SUNDRY NOTICES AND REPORTS ON WELLS
Do not use this form for proposals to drill or to re-enter an abandoned well. Use form 3160-3 (APD) for such proposals.

Revisions to Operator-Submitted EC Data for Sundry Notice #429916

RE: 202 LINE LEAK WORK PLAN

Department Of Interior- Bureau of Land Management – Tres Rios Field Office – COAs

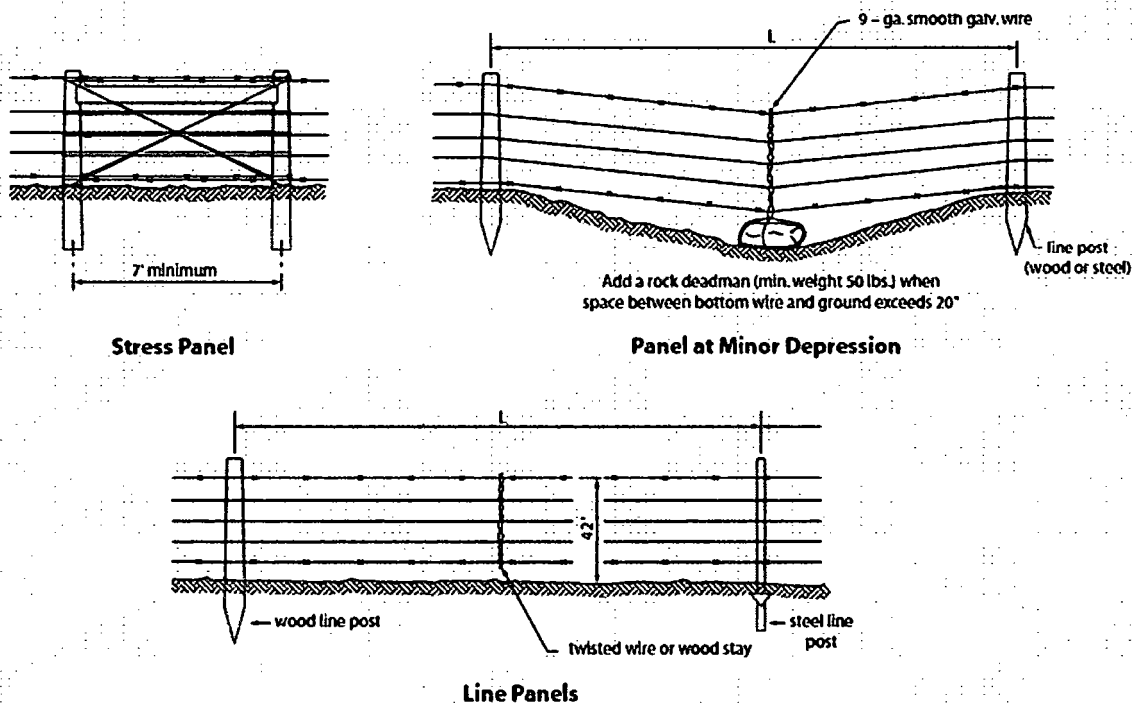
- 16. (Comment) Operator will remove the winter closer section of the approved work plan.
